Re: Recall No. 08V-048 Supplemental Information

MODEL: 2008 CONCOURS™ 14/14 ABS (ZG1400A8F/L, ZG1400B8F/L)
TITLE: REPLACEMENT REAR CARRIER PLATFORM

RECALL

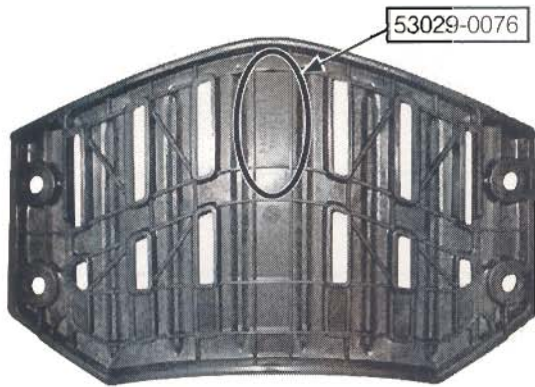
Return any original rear carrier platform (P/N 53029-0064) in your dealer inventory to KMC for credit. Use a Request for Credit form (P/N 99995-502) and reference Recall MC 08-02 in the Additional Information section.

Presence of the new rear carrier platform with embossed part number 53029-0076 will serve as repair verification.
